6621A-14

S E R V I C E N O T E

6621A DC Power Supply

Intermittent Power Transformer “Magma” Connections

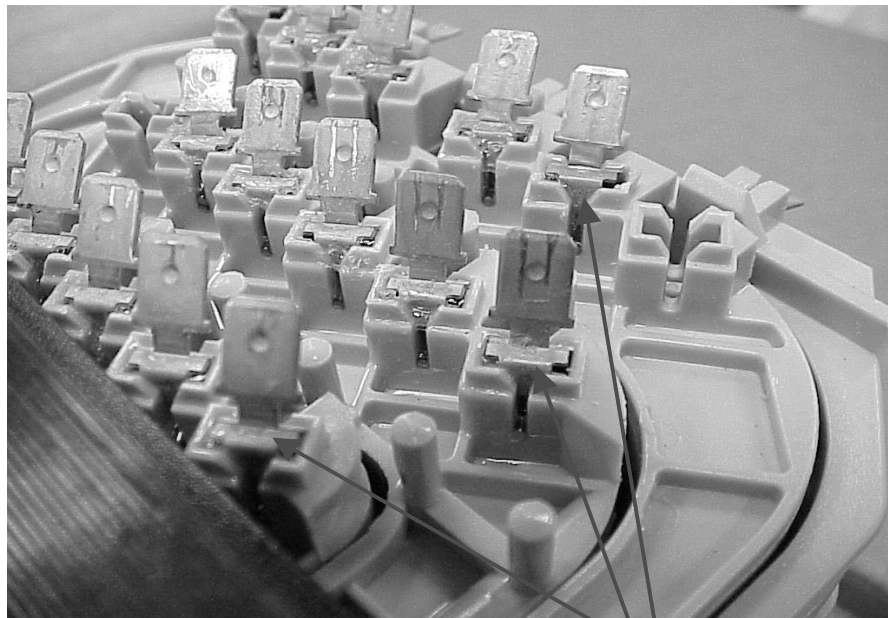
The power transformer vendor mistakenly installed the wrong “Magmates” in a run of power transformers. The incorrect “Magmates” have a # 43 stamped on them, which corresponds to a 15 gauge wire size. The correct size “Magma” should be # 24 designed for a 19 gauge wire size.

This could result in a variety of intermittent as well as steady hardware problems and errors. Examples: HDW ERR CH 1, Blank front panel display, not meeting specifications.

Replace the Power Transformer with a new replacement Transformer, see the table above for the correct power transformer part number.

NOTE: Please inspect the new transformer for the correct “Magma” number stamping.

Top View of Power Transformer:

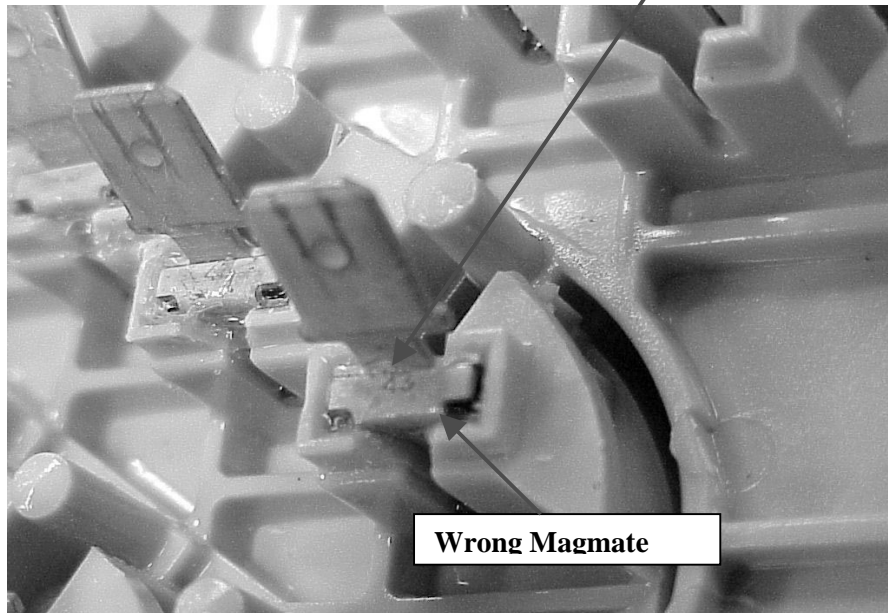
Incorrect “Magma” number 43 on the Surface, This should be number

Wrong Magma
